Bike Winnipeg Recommendations - Airport Area West Residential Secondary Plan

Recommended additional language is shown in **bold**.

Map of recommended internal and internal bikeway connections for the Airport Area West Residential Secondary Plan. Bike Winnipeg, 2021.

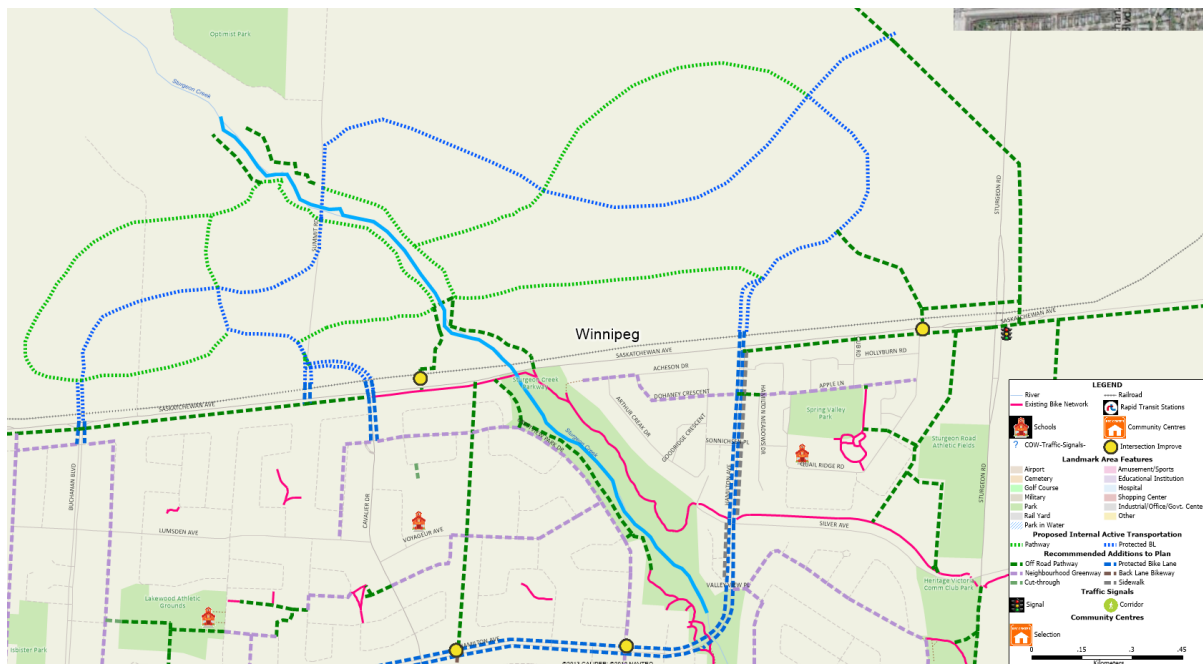
With no schools or community clubs planned within the development area, safe, comfortable, and convenient pedestrian and cycling connections to schools and community clubs outside of the planned development will be essential. The proposed plan drops all cycling facilities at the southern boundary of the development area, and fails to match the cycling facilities exiting the new community to those it proposes to connect to. In doing so, it fails to provide the connectivity needed under Complete Communities and within the plans own guiding principle of a transportation network that considers the needs of all users – pedestrians, cyclists, public transportation and private motor vehicles.

We therefore recommend that **cycling facilities along Buchanan Blvd, Cavalier Dr, and Hamilton Ave, as well as their extensions into the planned development area be implemented through the use of one-way protected bike lanes**. With short sections of retrofitted roadway that can be transitioned back to the existing roadway, this treatment can be used to provide needed access into the adjacent neighbourhoods by providing quality connections to low volume residential roads that will provide interim connectivity to schools and community clubs in the Buchanan, Crestview, and Heritage Park neighbourhoods until planned treatments can be installed along the full length of the connecting streets.

In addition to the three proposed connections across Saskatchewan Ave, **we recommend adding a fourth crossing of Saskatchewan Ave at Quail Ridge Rd making use of the existing rail crossing.** This crossing could limit through traffic to persons on foot or bike to minimize traffic through flow. Such a crossing is needed to provide reasonably direct access to the planned Sturgeon Rd pathway that will be constructed along with the widening of Sturgeon Rd required by this plan.

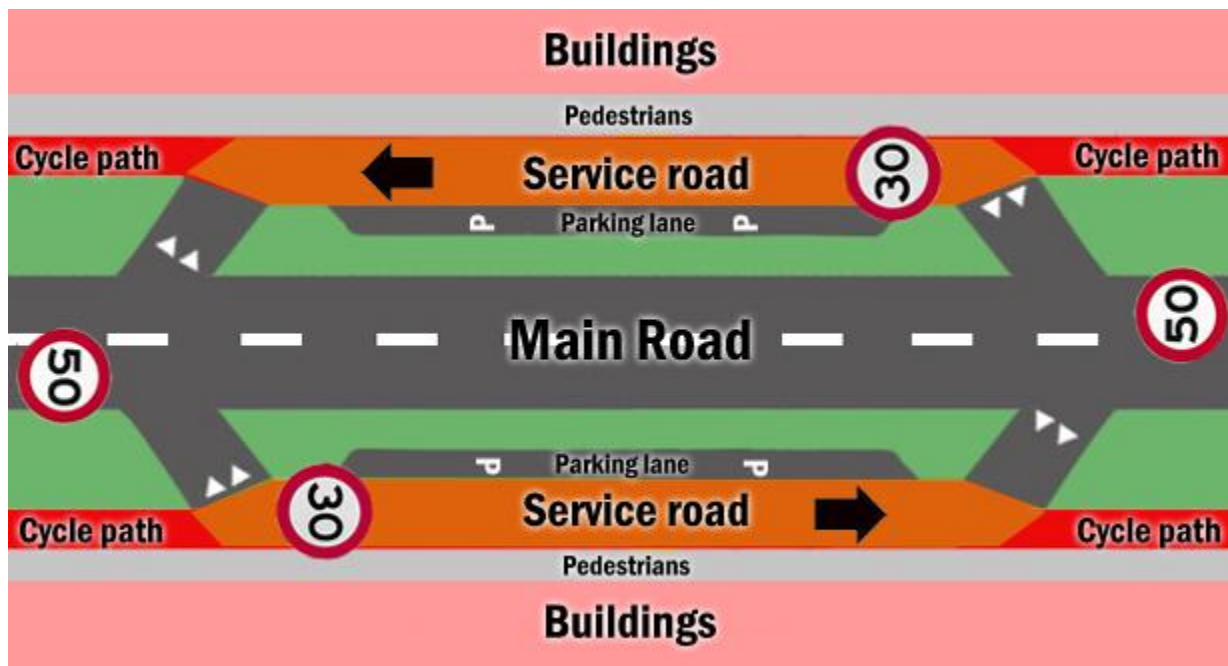
We recommend that the private access crossing of the Glenboro rail line to the east of Hamilton across from Quail Ridge Rd be incorporated into the internal bike network as a mixed use roadway.

Without this fourth crossing, important connections to Ecole Romeo Dallaire, the Sturgeon Rd Athletic Grounds, the Yellow Ribbon Trail, rapid transit stops, and Heritage Victoria Community Club will require a significant detour for any residents located in the eastern half of the plan area.

Figure 5.6.9 Protected Intersection

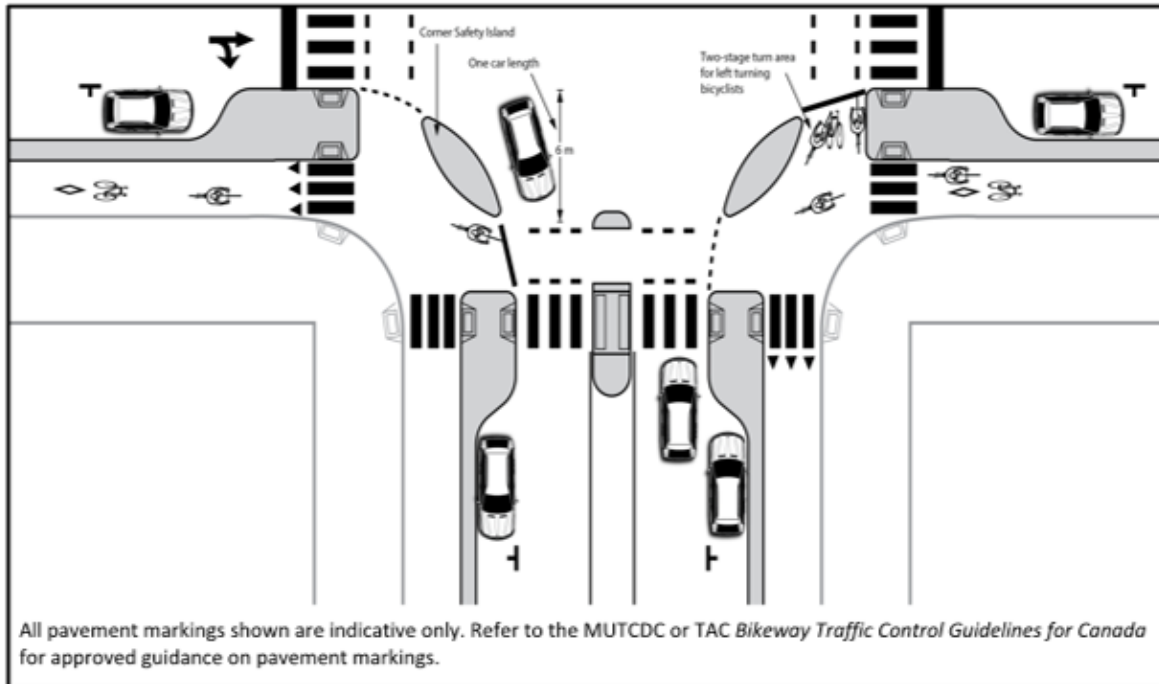
B. Intersections with collector streets will be designed as Protected Intersections

Protected intersections greatly increase safety and comfort of people biking through intersections along protected bike lanes by extending their protection through the intersection.

The corner radius of the corner safety island should be as small as feasible to accommodate the design vehicle yet encourage slow motor vehicle speeds and appropriate yielding behaviour.
